Ref: FCC Class II Permissive change for FCC ID: 2AKIT-CHH03

Applicant: Lumi United Technology Co., Ltd.

This is to request a Class II Permissive change for FCC ID: 2AKIT-CHH03 originally granted on 09/09/2021.

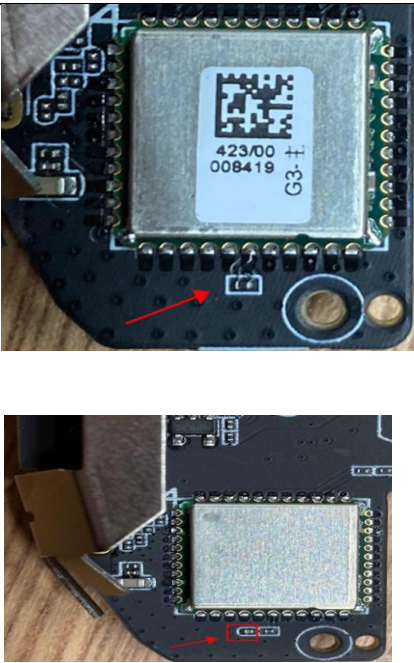
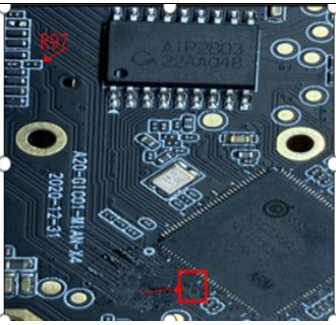
The Original Version		The New Version	
Change 1. Parameter before change	Bit number C160 is vacant	Parameter after Change	Add C160 capacitor, capacity : 12pF

<p>Change front view 1</p>		<p>Changing the rear view</p>	
<p>Change 2. Add components</p>	<p>1, R97 location as shown below 2, R17, C158, and C159 are empty as shown below 3, R34 is another name on the motherboard, under the camera</p>	<p>Parameter after Change</p>	<p>1, Move bit number R97 position. 2, Move bit number R34 position. 3, Add resistor R17=120R, capacitor C158=27pF, C159=27pF</p>
<p>Change front view 2</p>		<p>Changing the rear view</p>	
<p>Change 3. Change component parameters (Change pcba: usb small version)</p>	<p>bit number: L1 (resistor) Parameter: 0R (usb small version)</p>	<p>Parameter after Change</p>	<p>bit number: L1 (magnetic bead) Parameter: magnetic bead value: 100MHz@120ohm magnetic beads (usb small version)</p>

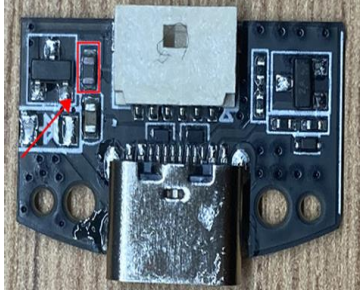
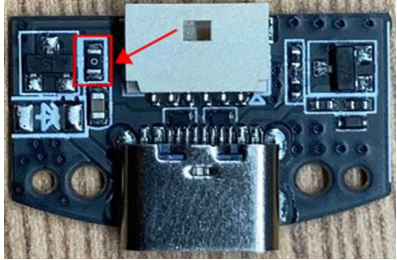
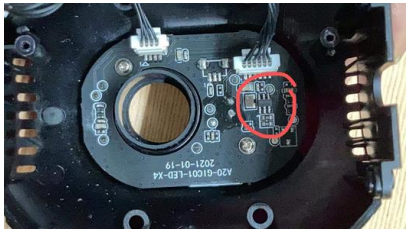
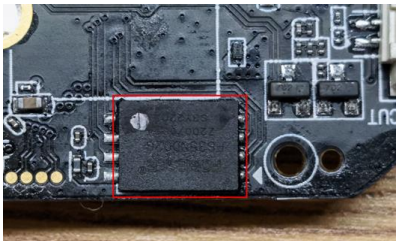
<p>Change front view 3</p>		<p>Changing the rear view</p>	
<p>Change 4. Parameter before change (U1 added one replacement suppliers)</p>	<p>bit number: U1 parameter : 2. 8V~30V\1MHz\2A\0. 6mA\SOT23-6 SILERGY SY7200AABC</p>		<p>bit number: U1 A: parameter : 2. 8V~30V\1MHz\2A\0. 6mA\SOT23-6 SILERGY SY7200AABC B: parameter : 2. 7~6V\60mA\0. 8MHz\1A\SOT23-6 ETA ETA1617S2G</p>
<p>Change front view 4</p>		<p>Changing the rear view</p>	
<p>Change 5. Parameter before change</p>	<p>Bit number U6 is FORESEE/FS35ND02G-S3Y2QWFI000</p>	<p>Parameter after Change</p>	<p>Bit number U6 is 1. ESMT/F50L2G41XA -104YG2B 2. Winbond/W25N02KVZEIR</p>
<p>Change front view 5</p>		<p>Changing the rear view</p>	
<p>Change 6. Add components</p>	<p>Bit number U19 is HDSC/HC32F005C6UA</p>	<p>Parameter after Change</p>	<p>Bit number U19 is Cmsemicon/CMS32L031QN20</p>

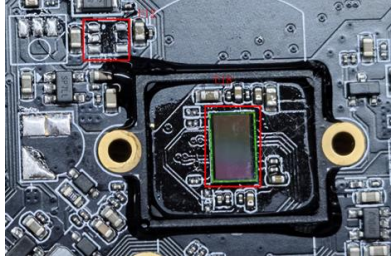
<p>Change front view 6</p>		<p>Changing the rear view</p>	
<p>Change 7. Change component parameters (Change pcba: usb small version)</p>	<p>1.Bit number U18 is SmartSens/SC3335; 2.Bit number U12 is 1.2V LDO.</p>	<p>Parameter after Change</p>	<p>1.Bit number U18 is SmartSens/SC3338; 2.Bit number U12 is vacant.</p>
<p>Change front view 7</p>		<p>Changing the rear view</p>
